**Steel — Charpy V-notch pendulum impact test — Instrumented test method**

**AMENDMENT 1: Annex D — Instrumented Charpy V-notch pendulum impact test of sub-size test pieces**

Amendment 1 to ISO 14556:2000 was prepared by Technical Committee ISO/TC 164, *Mechanical testing of metals*, Subcommittee SC 4, *Toughness testing — Fracture (F), Pendulum (P), Tear (T)*.

**Figure D.1 — Impact test on sub-size Charpy V-notch specimen**

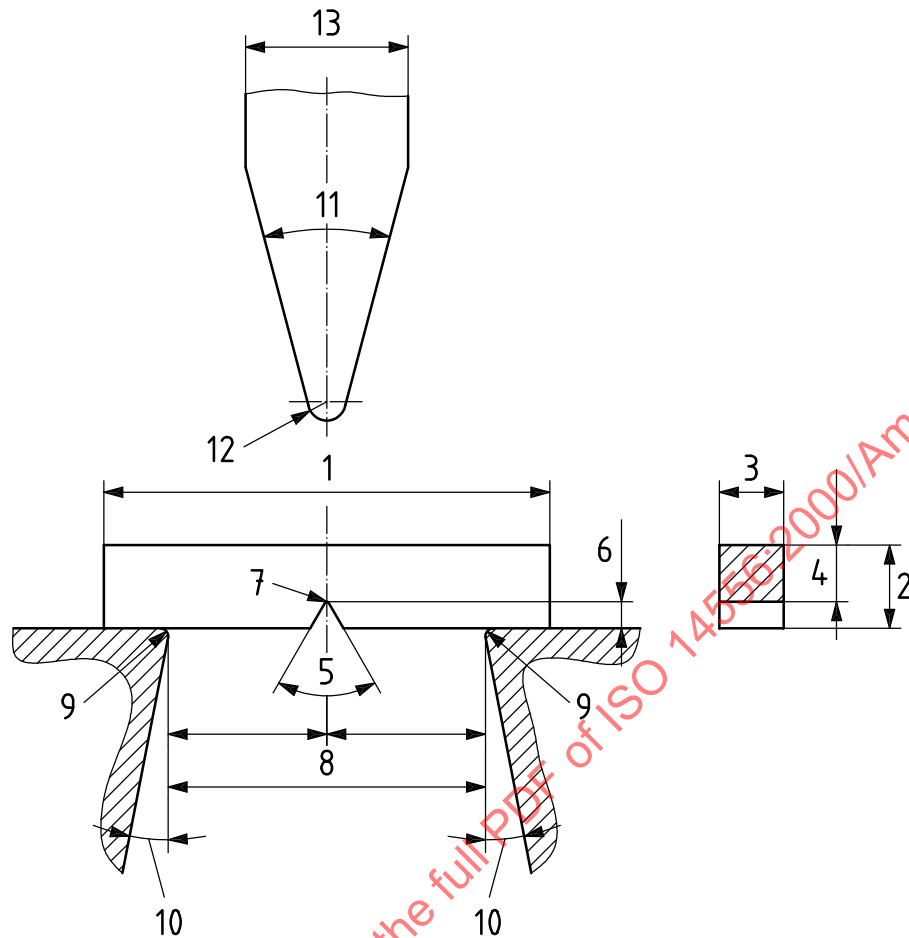
The testing machine is similar to that used for conventional Charpy V-notch test pieces, with the exception of the following characteristics, which have to be suitably modified taking into account the dimensions of the test piece (Figure D.1): impact velocity, distance between the anvils, positioning of the specimen with respect to the striking edge.

| Reference number | Designation                    | Value                 |
|------------------|--------------------------------|-----------------------|
| 1                | Specimen length                | 27 mm $\pm$ 0,50 mm   |
| 2                | Specimen height                | 4 mm $\pm$ 0,05 mm    |
| 3                | Specimen width                 | 3 mm $\pm$ 0,05 mm    |
| 4                | Height below notch             | 3 mm $\pm$ 0,05 mm    |
| 5                | Angle of notch                 | 60° $\pm$ 1°          |
| 6                | Notch depth                    | 1 mm $\pm$ 0,05 mm    |
| 7                | Notch-root radius              | 0,1 mm $\pm$ 0,025 mm |
| 8                | Distance between anvils (span) | 22 mm $^{+0,10}_0$ mm |
| 9                | Radius of anvils               | 1 mm $^{+0,50}_0$ mm  |
| 10               | Angle of taper of anvils       | 11° $\pm$ 1°          |
| 11               | Angle of taper of striker      | 30° $\pm$ 1°          |
| 12               | Radius at tip of striker       | 2 mm $^{+0,50}_0$ mm  |
| 13               | Width of the striker           | 6 mm to 12 mm         |

Notch length to edge: 90°  $\pm$  2° — Adjacent sides shall be at 90°  $\pm$  1°.

Finish requirements: roughness  $Ra$  2 on notched surface and  $Ra$  4 on the other two surfaces.

Figure D.2 — Example of a support block for the calibration of a 2 mm striker used for testing sub-size test pieces

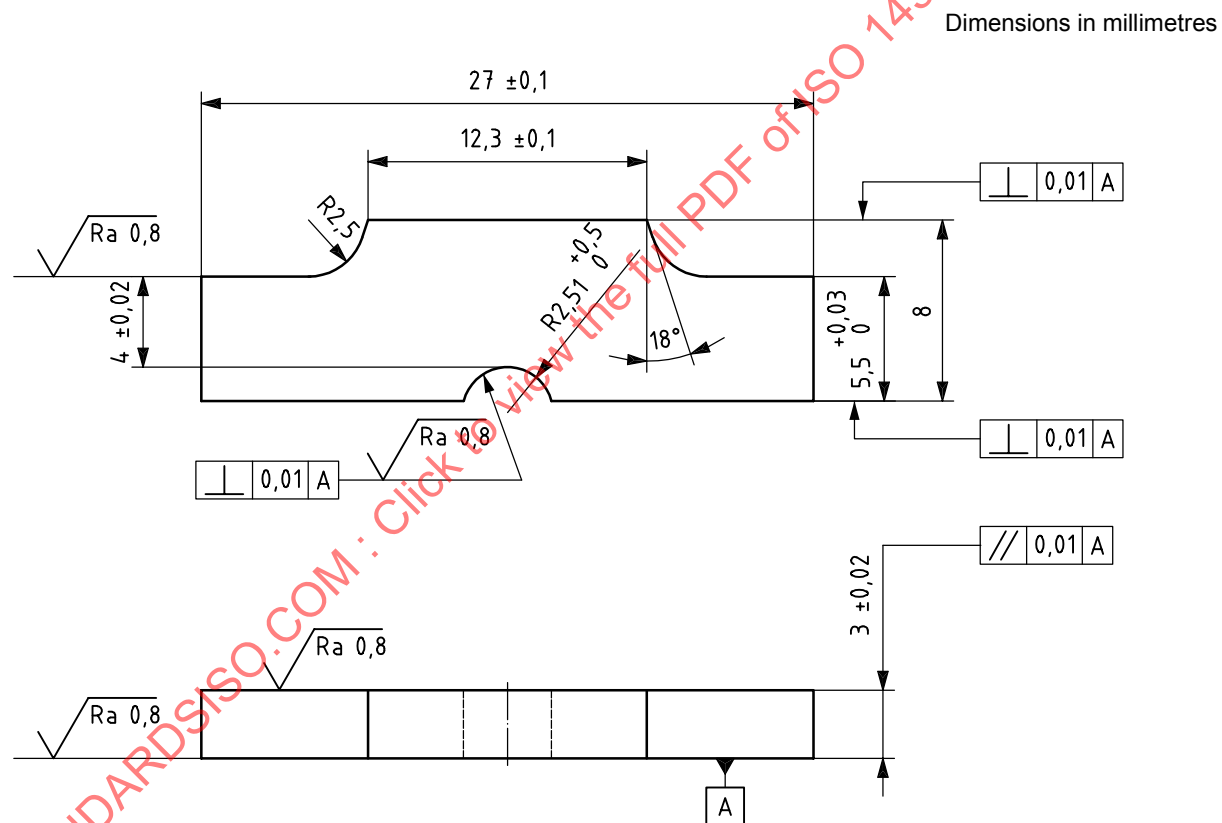
An example of the support block for the static calibration of a 2 mm striker used for testing sub-size test pieces is shown in Figure D.2.

Figure D.3 – Alternative sub-size Charpy V-notch specimens

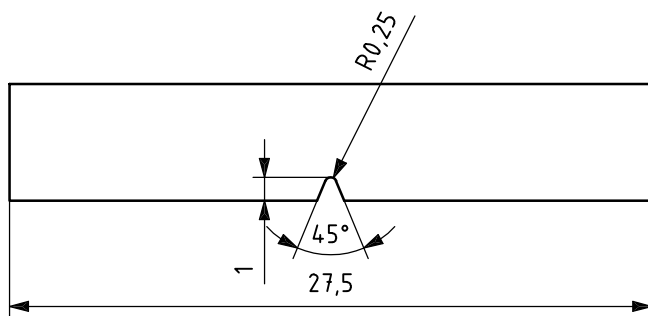
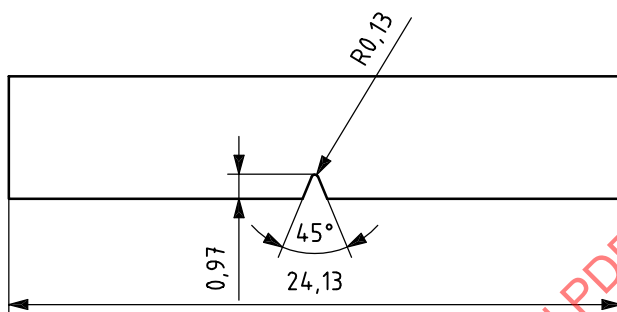
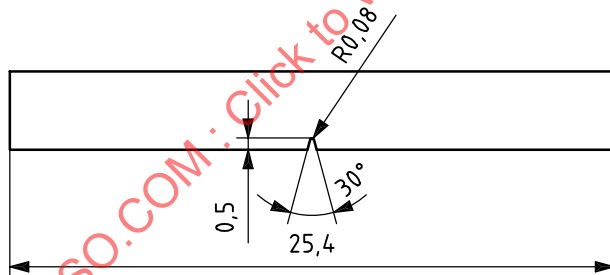
The test piece is a sub-size Charpy V-notch test piece, conforming to the dimensions specified in Figure D.1. Other specimen geometries can be used, by agreement; designs of other sub-size test pieces that have been successfully used are shown in Figure D.3.

Finish requirements and geometrical tolerances are as in Figure D.1.
